Document Information			
Document #	0201741/02-RCA-0272	**Revision**	
Title	QUARTERLY NOTIFICATION OF CLASS 1 MODIFICATIONS TO THE HANFORD FACILITY RESOURCE CONSERVATION AND RECOVERY ACT (RCRA) PERMIT, DANGEROUS WASTE PORTION (QUARTER ENDING MARCH 31, 2002 - PERMIT CONDITION I.C.3)		
Date	04/09/2002		
Originator	J. HEBDON, R. H. GURSKE, R. D.(ROBY) ENGE	**Originator Co.**	DOE, FH, PNNL
Recipient	L. E. RUUD	**Recipient Co.**	DOEC
References			
Keywords			
Projects			
Other Information

APPENDIX 4B

DETAILED DRAWINGS FOR THE 200 AREA EFFLUENT TREATMENT FACILITY CONTAINER STORAGE AREA AND TANK SYSTEMS

ENGINEERING CHANGE NOTICE

Ref Dwg	Sh	Rev
H-2-88980	1	10

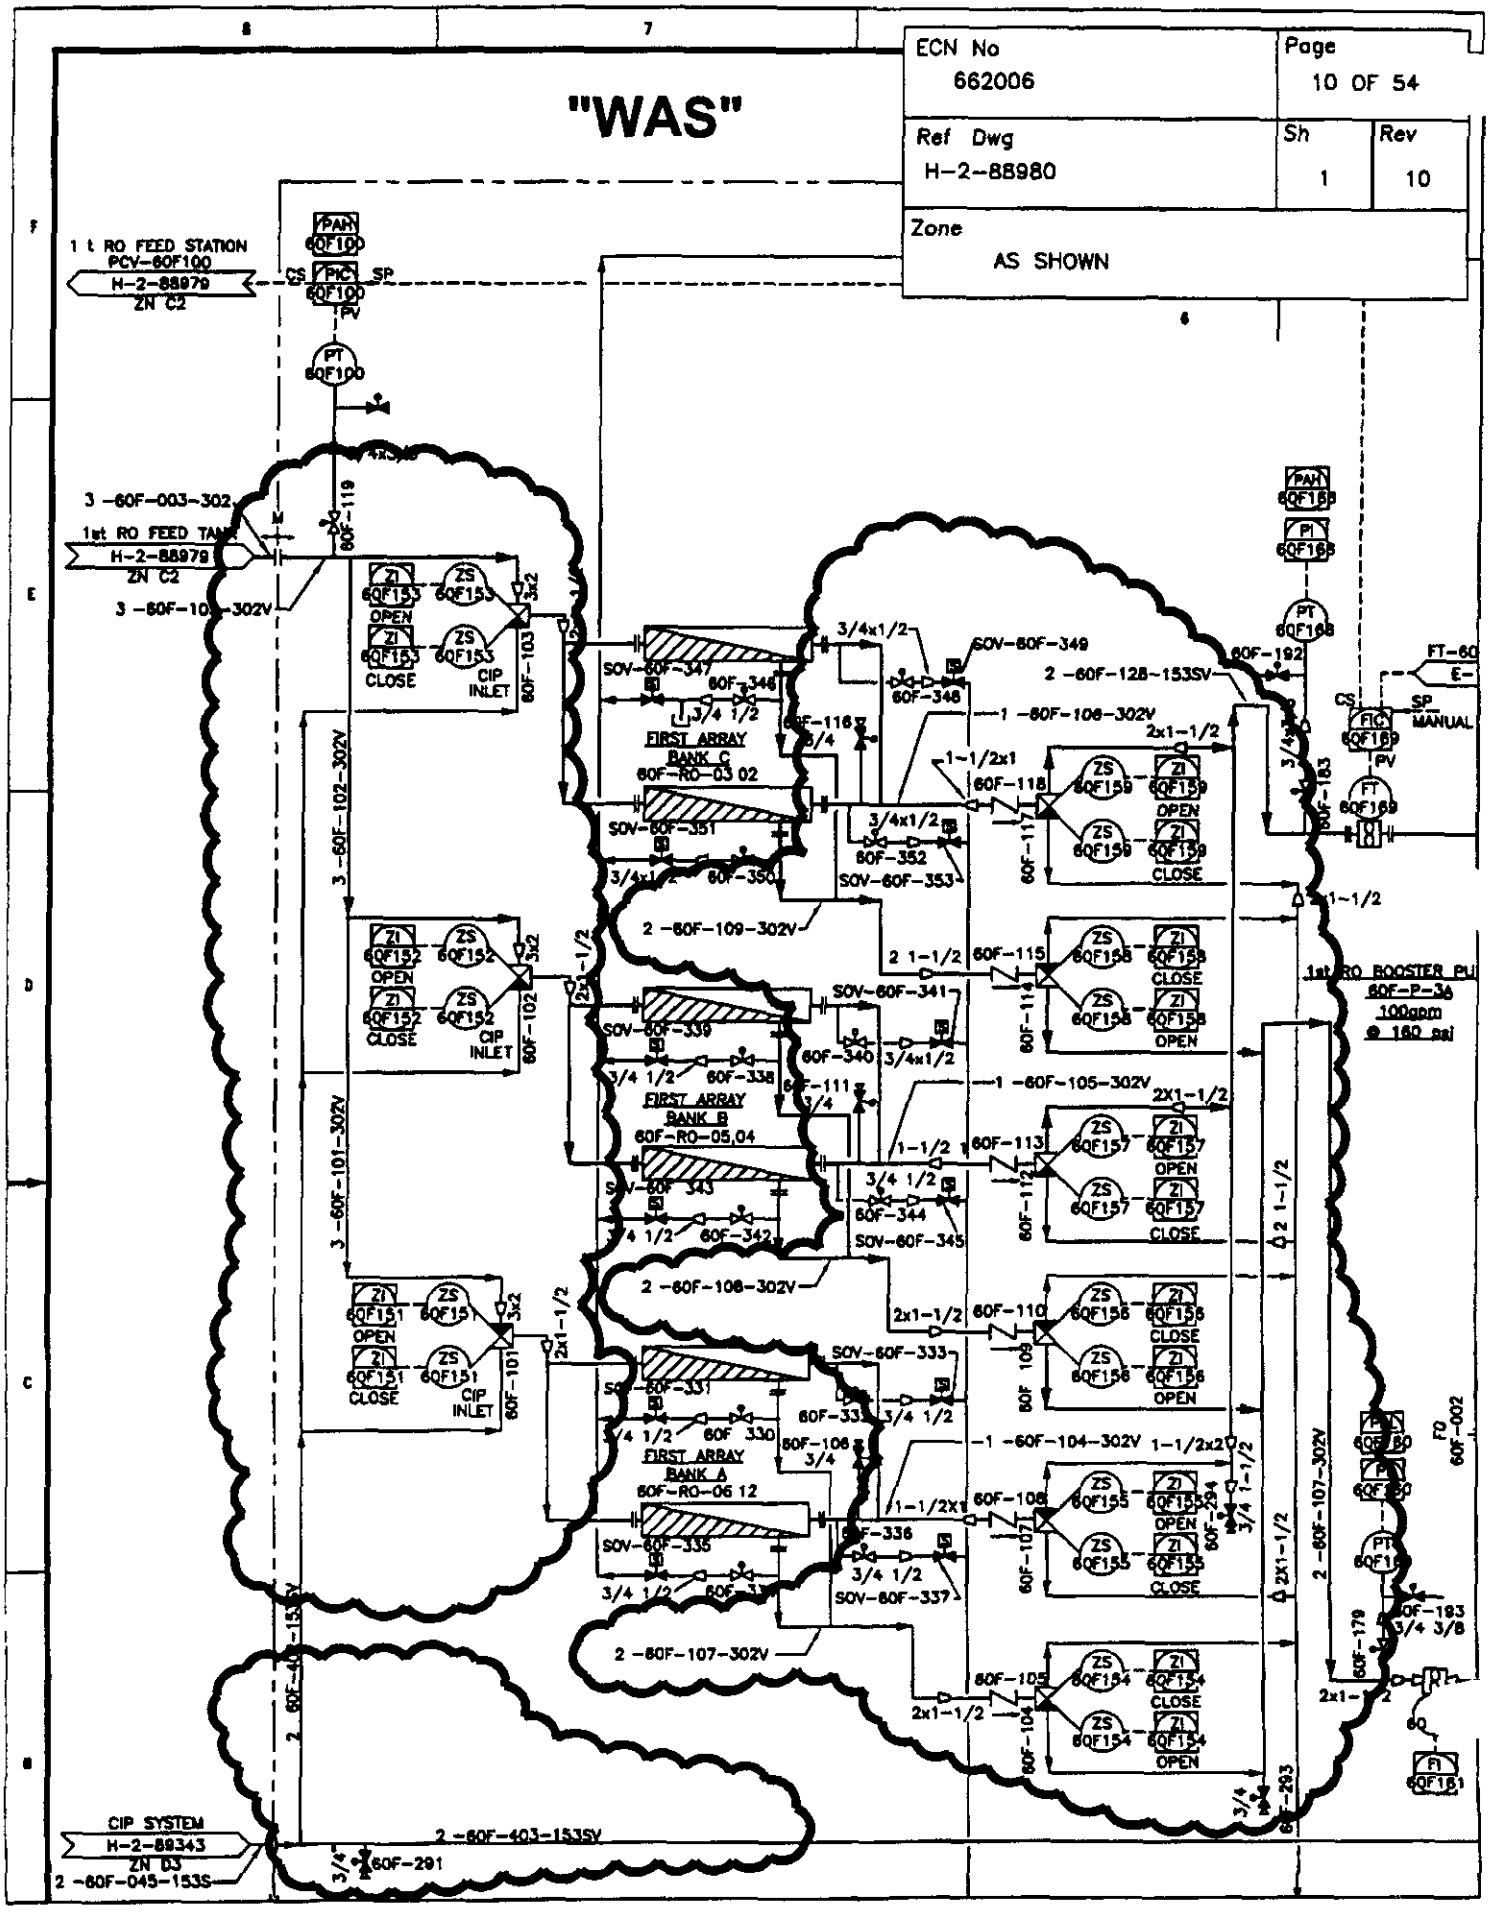
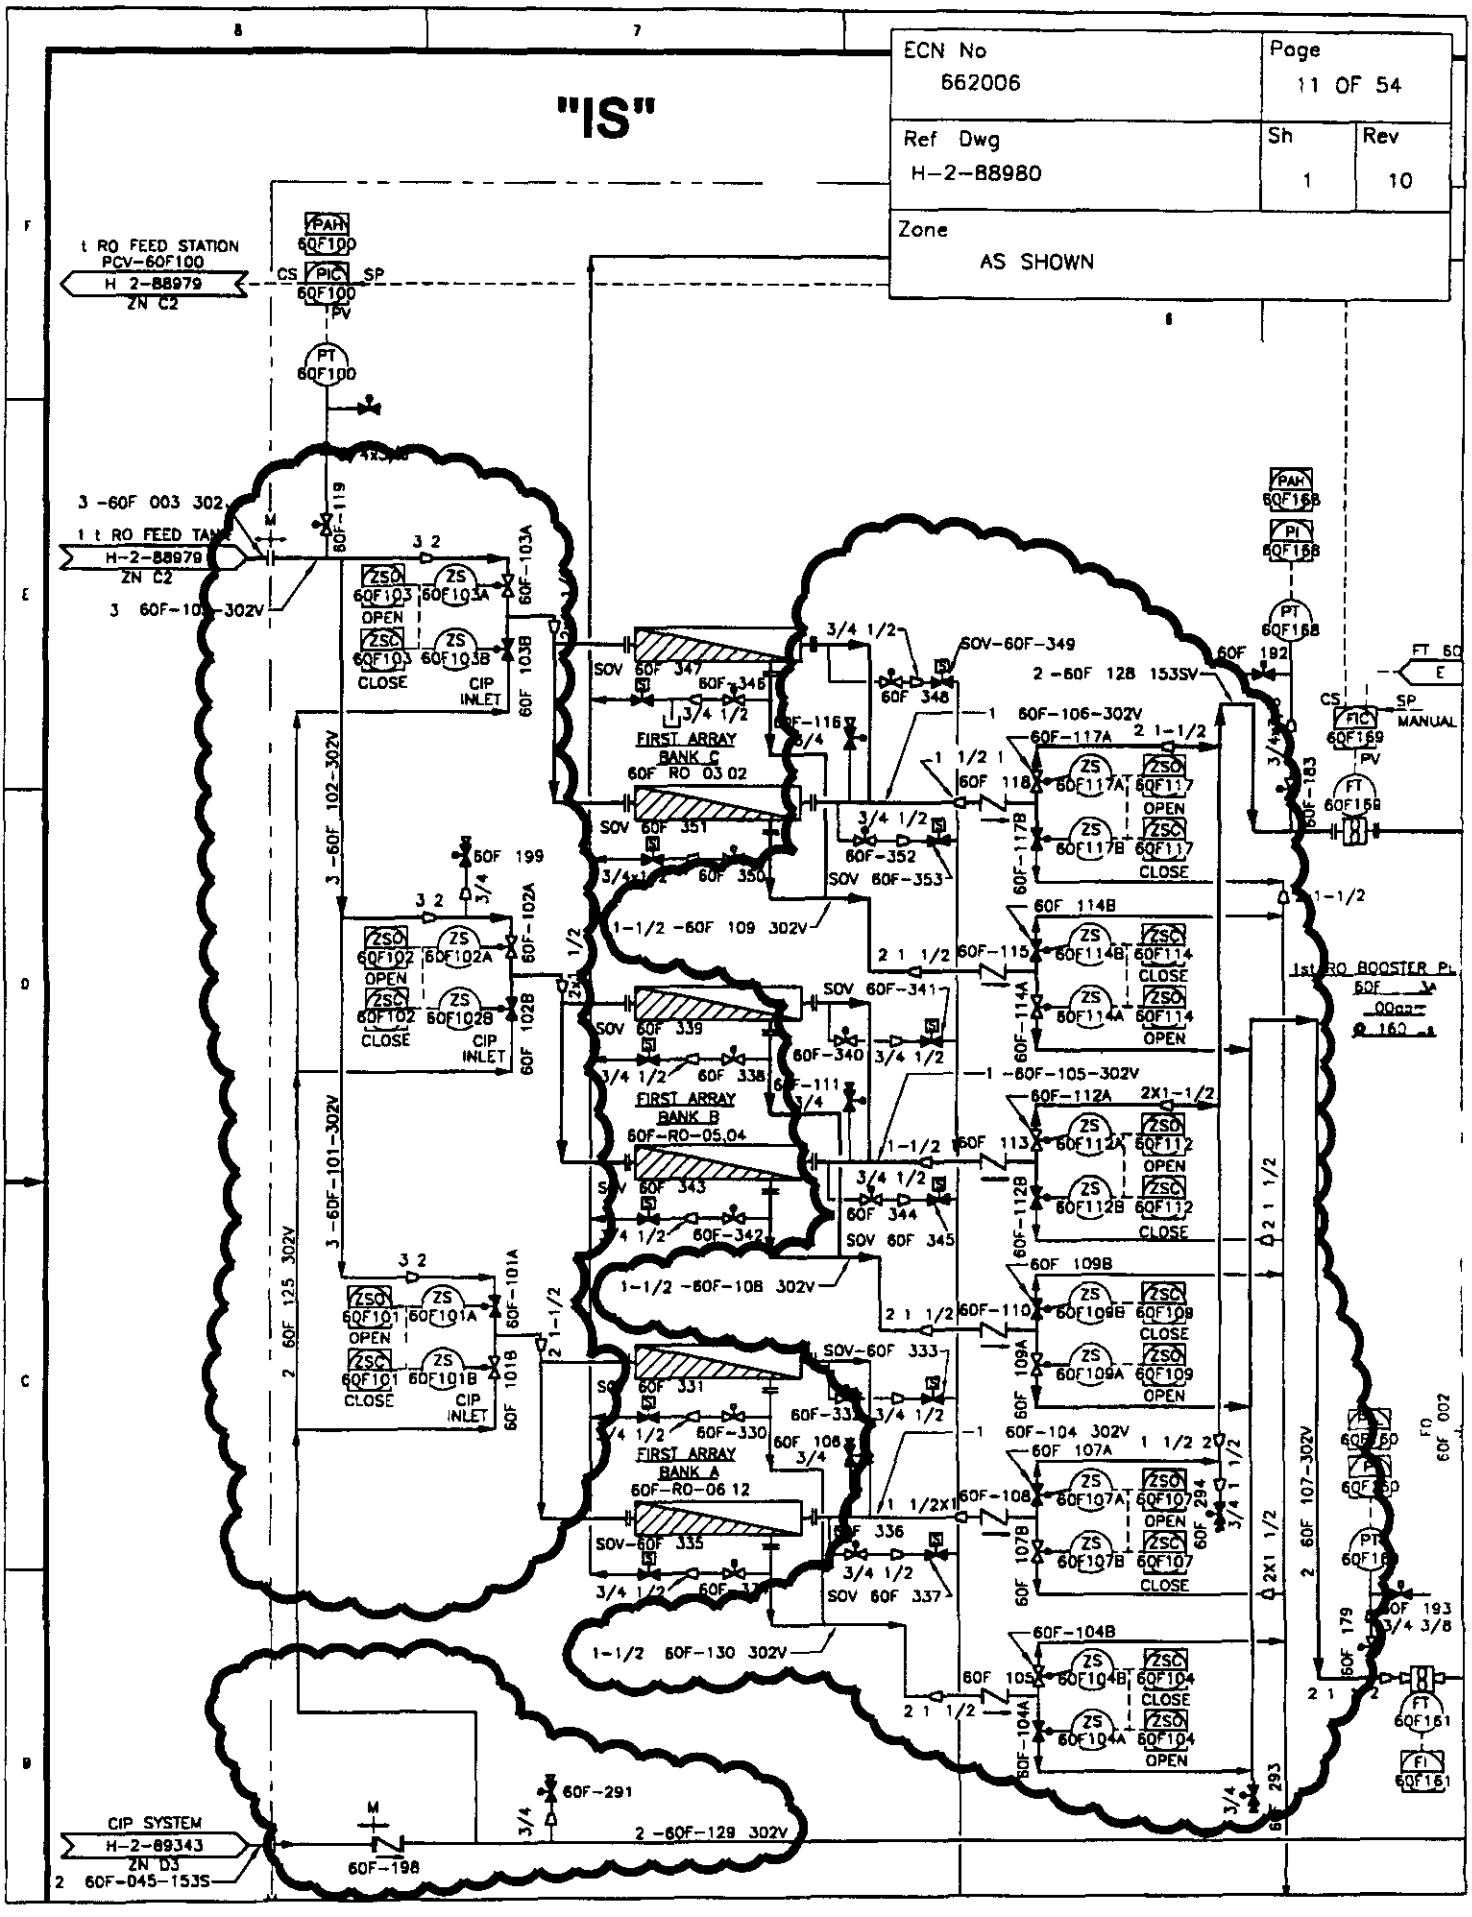
Remove and replace 3-Way ball valve 60F-103 with two 2-Way ball valves Label new valve downsteam of pipeline 3 -60F-103-302V with valve number 60F-103A Label other new 2-way valve 60F-103B

Show valve 60F-103A as open and 60F-103B as closed

Change label of (ZS) switch associated with new valve 60F-103A to ZS-60F103A

Change label of (ZS) switch associated with new valve 60F-103B to ZS-60F103B

Change label of two (ZI) inputs from 60F153 to 60F103

Show electrical connection between ZS-60F103A and ZS-60F103B

Remove and replace 3-Way ball valve 60F-102 with two 2-Way ball valves Label new valve downsteam of pipeline 3 -60F-102-302V with valve number 60F-102A Label other new 2-way valve 60F-102B

Show valve 60F-102A as open and 60F-102B as closed

Change label of (ZS) switch associated with new valve 60F-102A to ZS-60F102A

Change label of (ZS) switch associated with new valve 60F-102B to ZS-60F102B

Change label of two (ZI) inputs from 60F152 to 60F102

Show electrical connection between ZS-60F102A and ZS-60F102B

Ref Dwg	Sh	Rev
H-2-88980	1	10

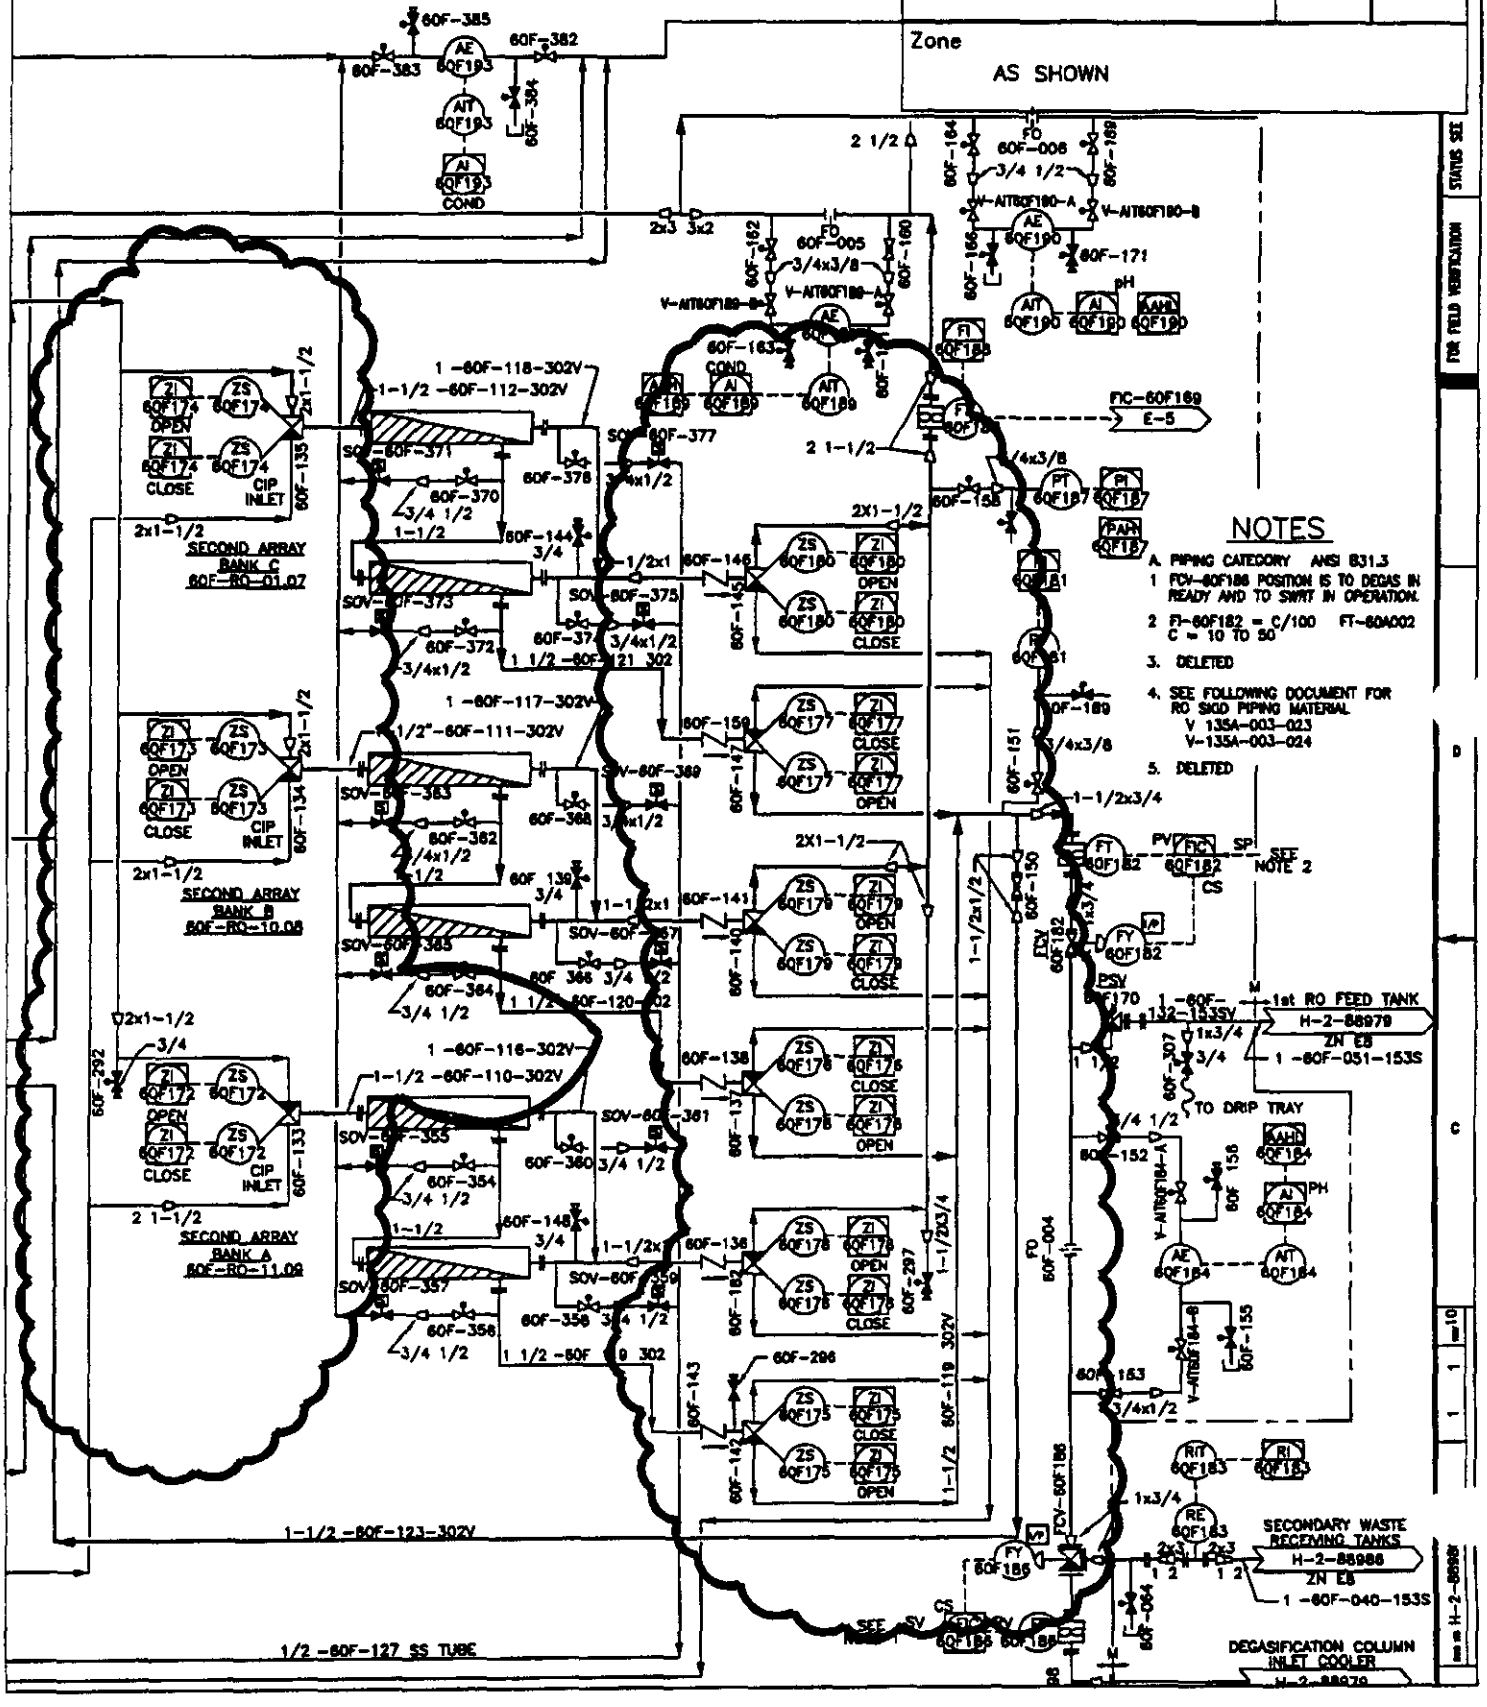
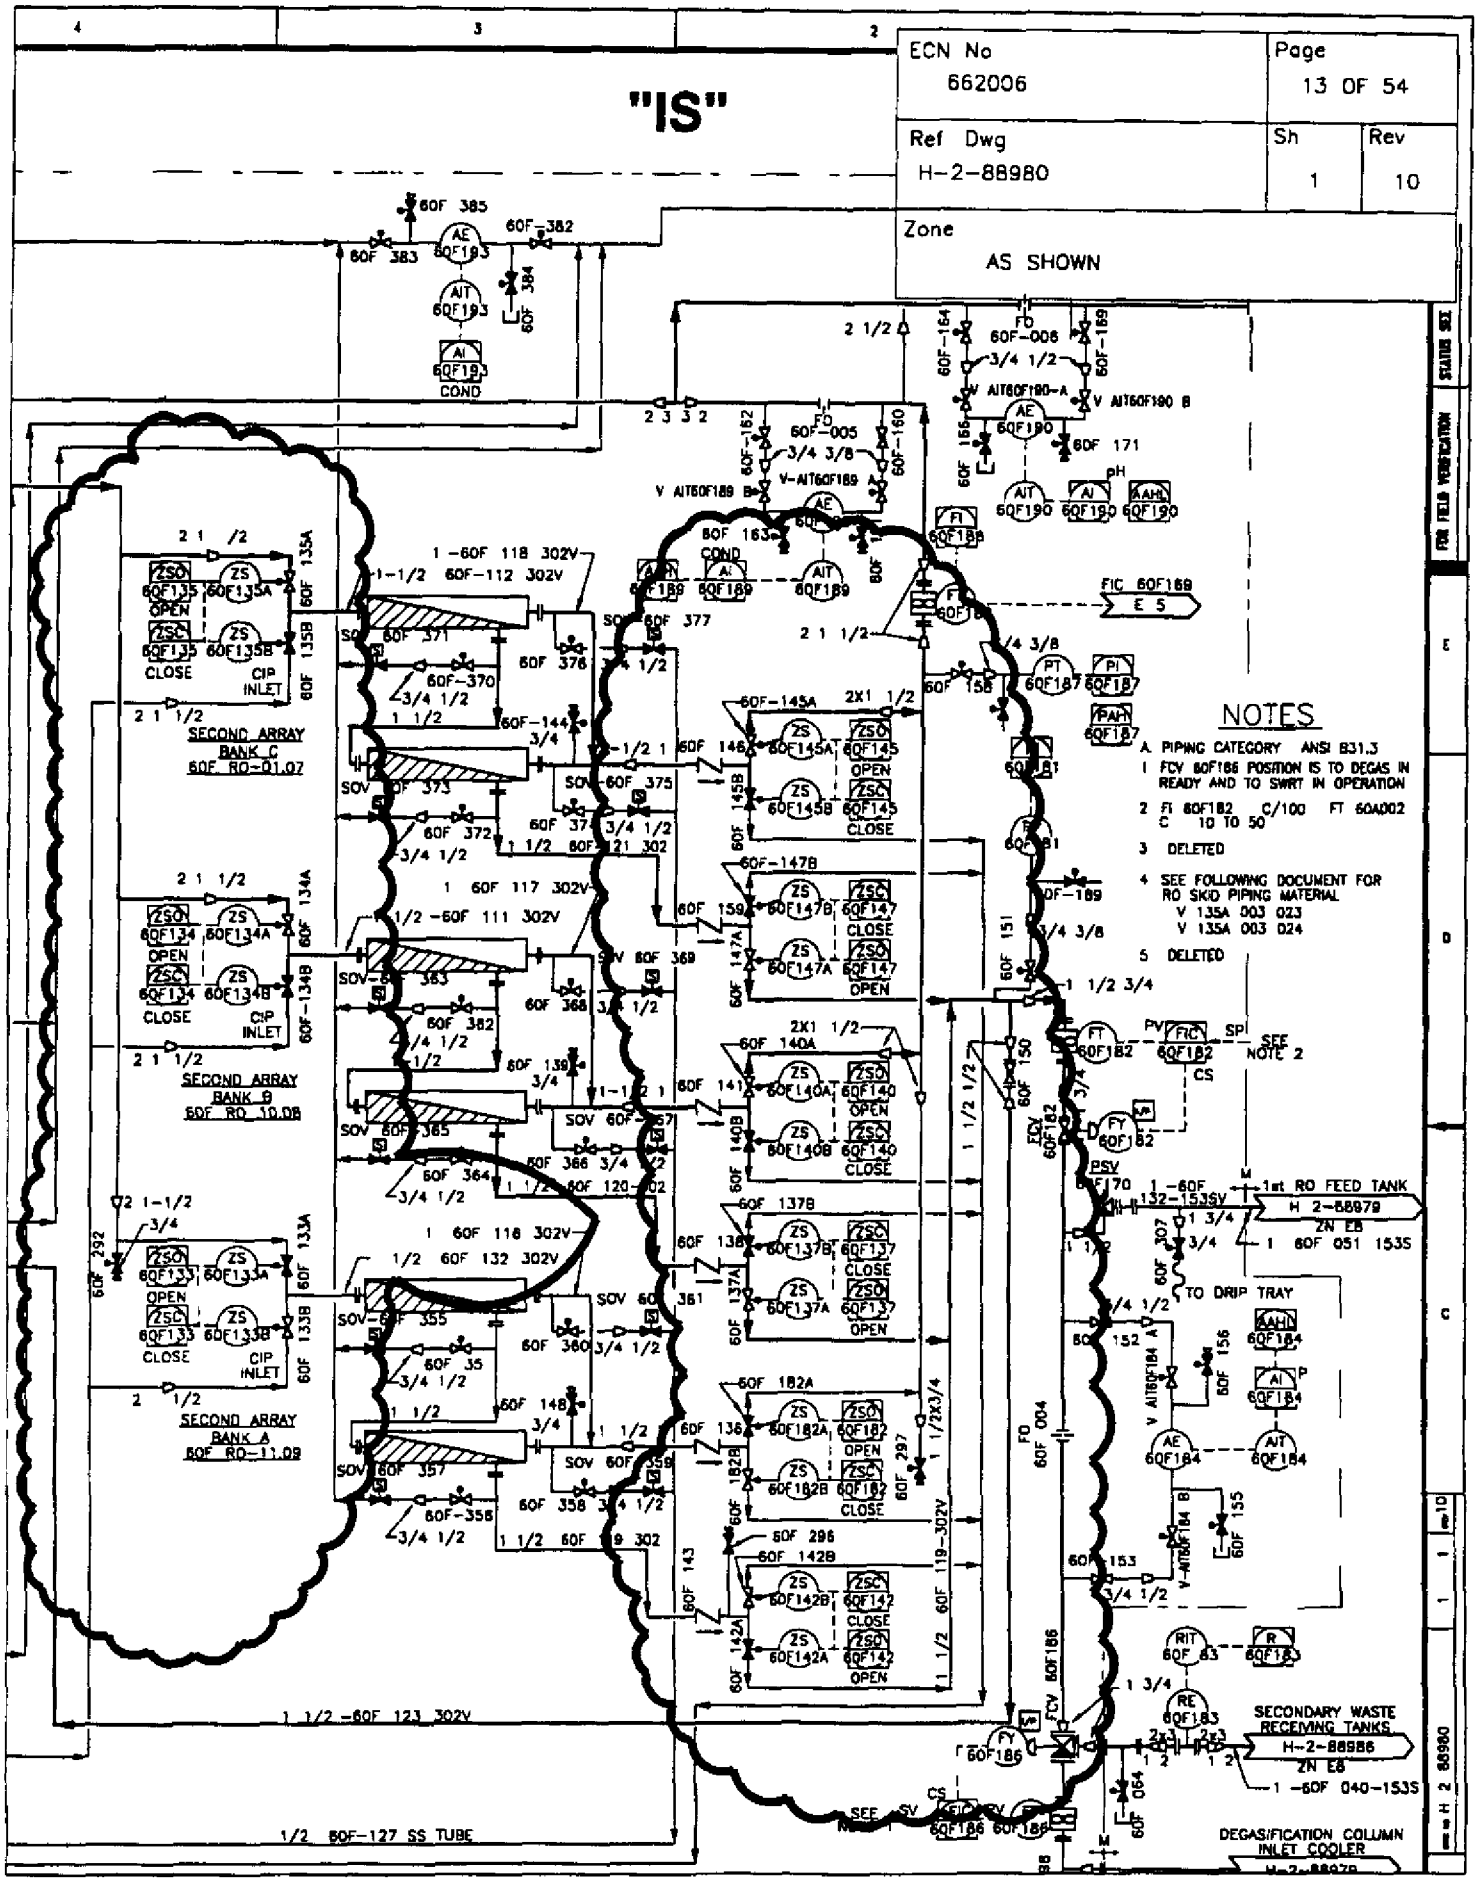
Remove and replace 3-Way ball valve 60F-101 with two 2-Way ball valves Label new valve downsteam of pipeline 3 -60F-101-302V with valve number 60F-101A Label other new 2-way valve 60F-101B

Show valve 60F-101A as closed and 60F-101B as open

Change label of (ZS) switch associated with new valve 60F-101A to ZS-60F101A

Change label of (ZS) switch associated with new valve 60F-101B to ZS-60F101B

Change label of two (ZI) inputs from 60F151 to 60F101

Show electrical connection between ZS-60F101A and ZS-60F101B

Change Pipeline label **2 -60F-108-302V** to **1-1/2 -60F-108-302V**
